Title V Air Operation Permit Renewal

DRAFT Permit Project No.: 0490015-005-AV

Hardee Power Station

Renewal of Title V Air Operation Permit Draft Permit Project No.: 0490015-005-AV

Table 2. Typical Target Values for Water-to-Fuel Ratio

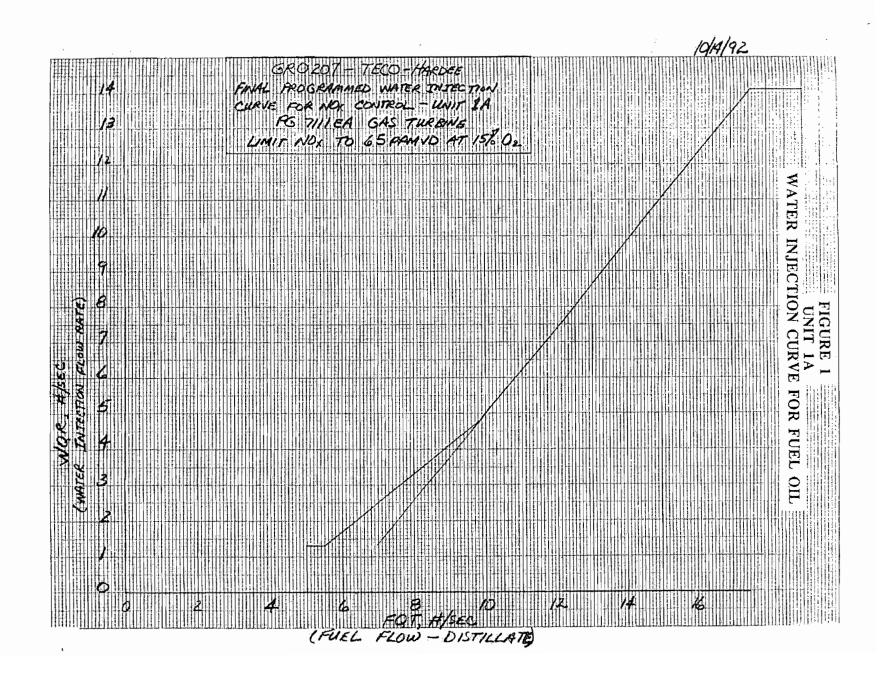
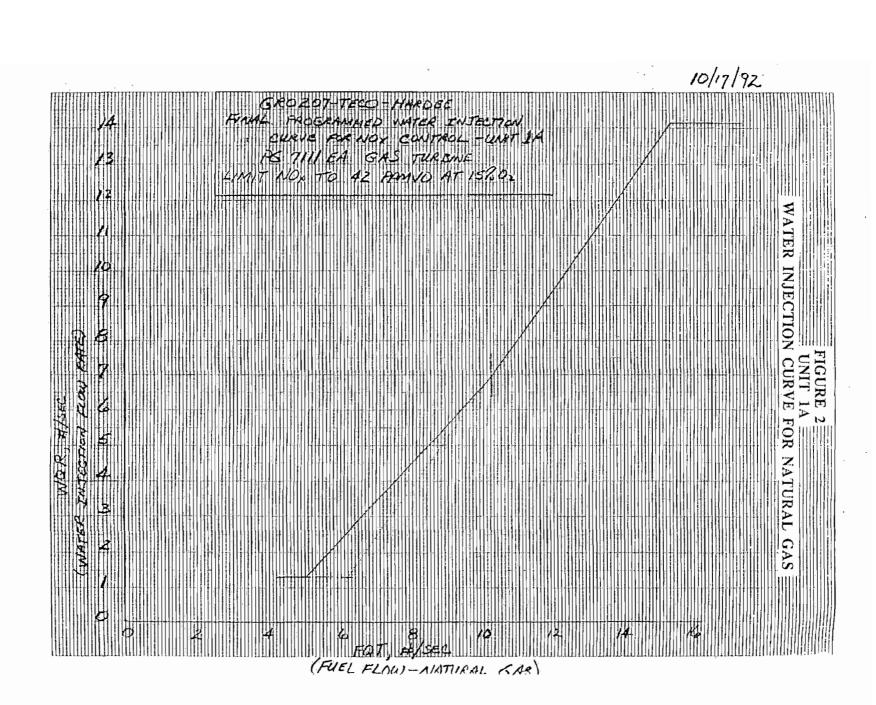
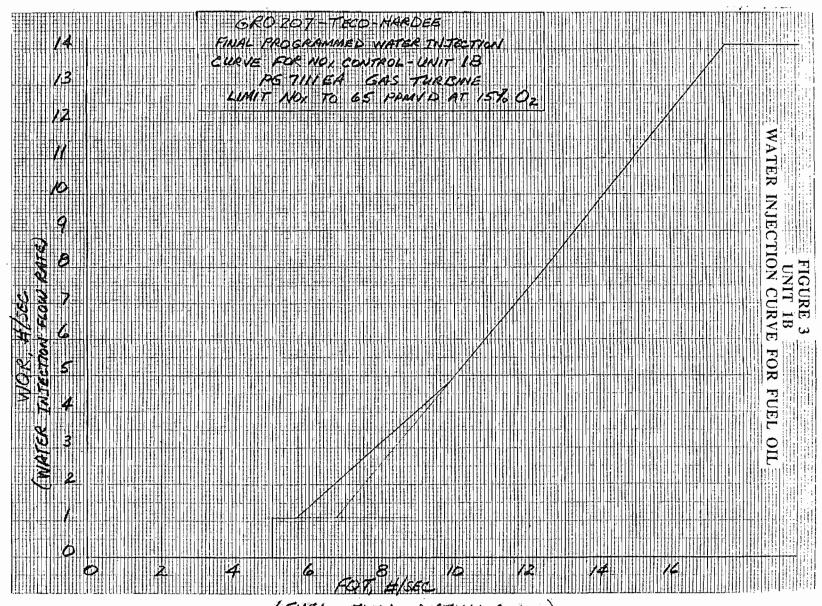
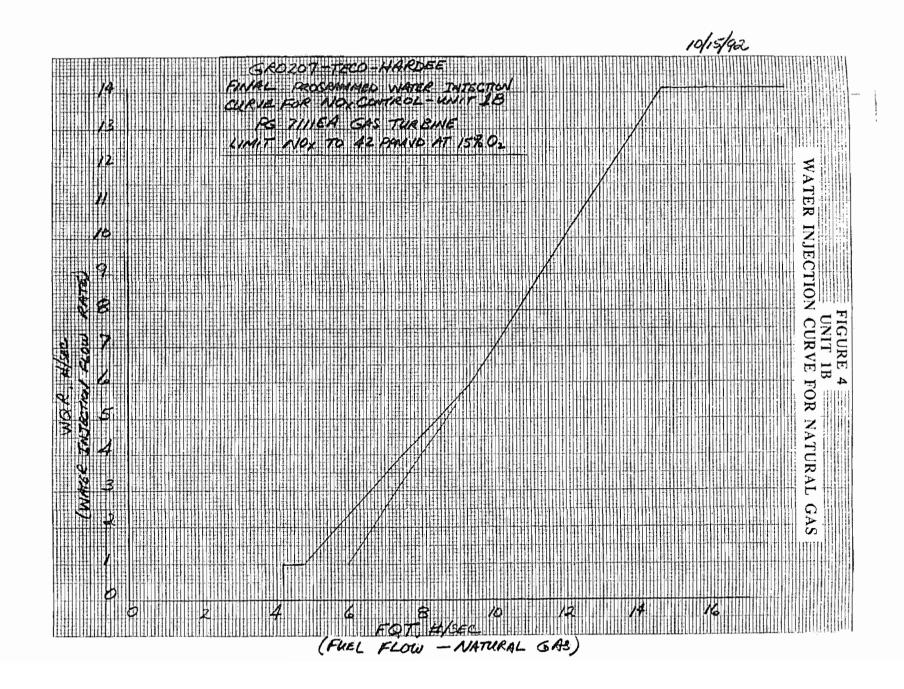
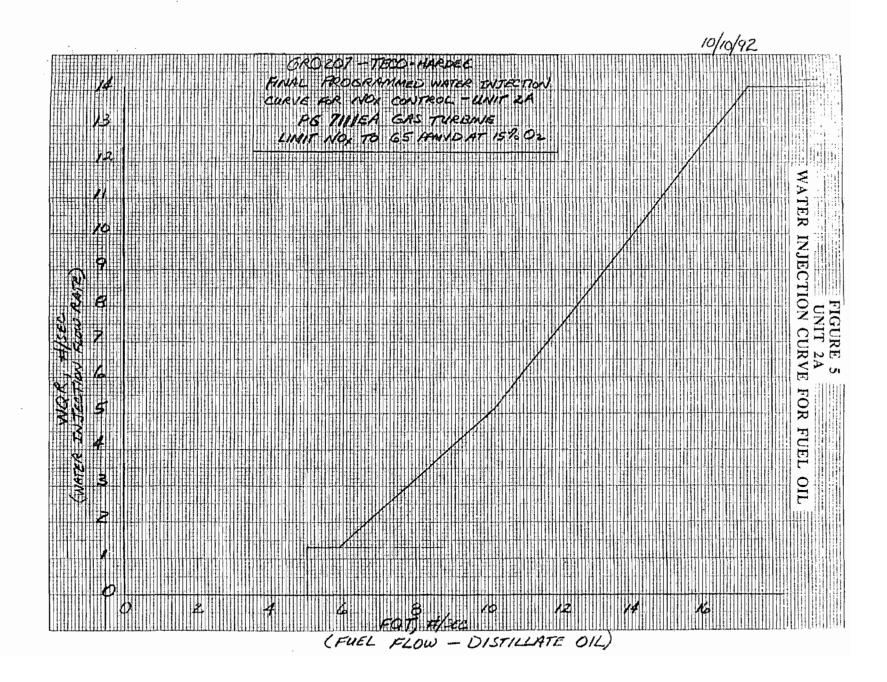
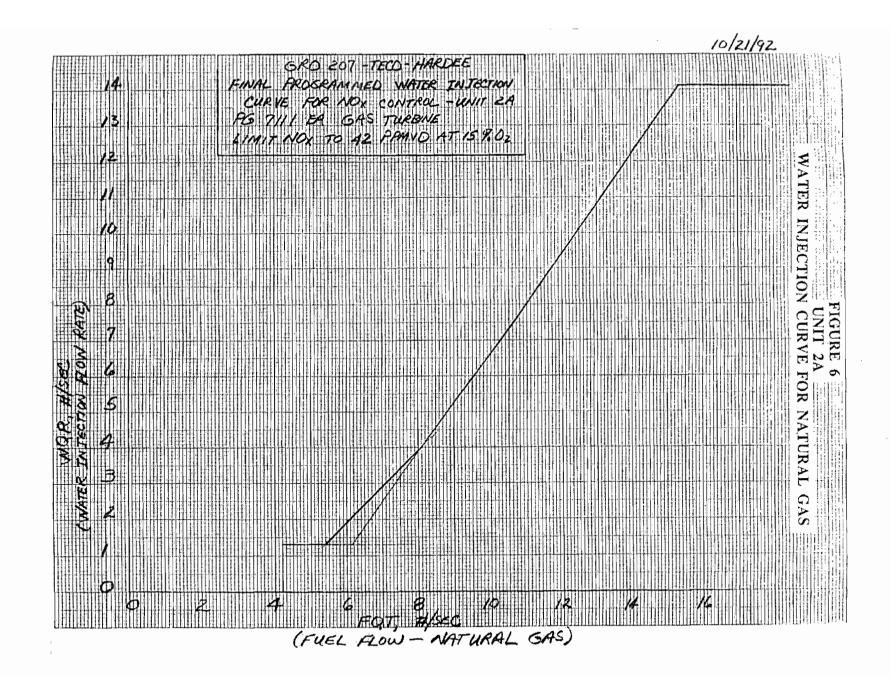
- 1. The CAM plan that was submitted for monitoring the water injection system did not include test data to justify the chosen indicator range. Please provide a table of test data that was used to establish the minimum required water-to-fuel ratios at the various load levels. In the table, provide the following information: Date of test, allowable operating rate, tested operating rate, allowable NO_X emission limit, tested NO_X emission limit, recorded water-to-fuel ratio. Include information for each emissions unit and each available test.

- 3. What is the maximum water-to-fuel ratio that can be sustained and still meet the allowable CO limit? While CO is not controlled, and therefore not subject to CAM, it is understood that increasing the water-to-fuel ratio causes an increase in CO emissions. Because of this, the CAM plan should also include a maximum water-to-fuel ratio in addition to a minimum water-to-fuel ratio.

See attachment 1 for the requested data. The CAM plan that was originally submitted did not include test data to justify an indicator range because we did not intend for the table of water-to-fuel ratios to serve as the "appropriate range" for reasonable assurance of ongoing compliance (as described in the Monitoring Design Criteria, 40 CFR 64.3 (a) (2)). For Hardee Power Station, we propose that the system to achieve this purpose is the alarm that alerts the

The programmed water-to-fuel ratio is based on manufacturer's data and the initial compliance testing conducted in 1992. At that time the water injection rate was optimized to provide the best emissions profile possible for all parameters. There was no testing conducted (nor is there a requirement for such testing) to determine the minimum injection rate at which the NOx rate would be out of compliance. Therefore, the water injection ratio could fall below the target ratios and still be in compliance with applicable standards. The calculated ratio is simply a target ratio at which we know results in compliance with applicable standards. If the actual ratio were to fall below the target ratio for an hour or more, the current permit requires that we report this period as excess emissions. This system has worked excellently for the past 12 years, as demonstrated by the annual compliance testing.

HARDEE POWER STATION UNITS 1A, 1B, & 2A ESTIMATED PERFORMANCE PG7121(EA) NATURAL GAS OPERATION

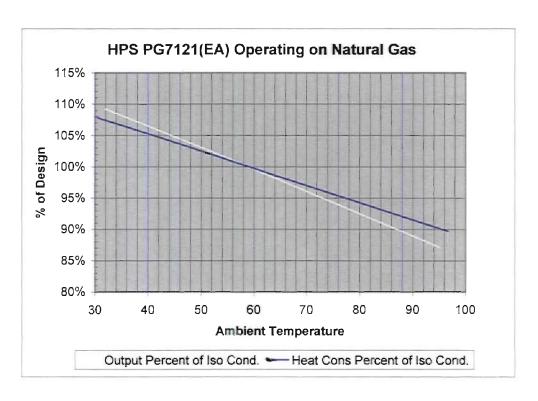
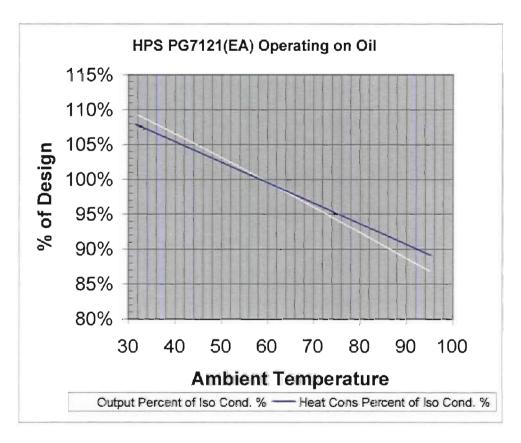
- 2. Provide heat rate curves for 1A, 1B, & 2A. TECO Response: The attached heat rate curves are based on discrete estimated base load values at various ambient temperatures provided by GE. See Appendix B.
- 3. Explain physical constraints for fuel usage at base load conditions. TECO response: The physical constraint that limits fuel combustion at base load is combustion turbine temperature. The combustion turbine control system (Mark IV) limits fuel flow to ensure that the combustion turbine temperature does not approach a level that would cause damage to the equipment.
- 4. Provide water-to-fuel ratio curves from the initial test report. See Appendix C.
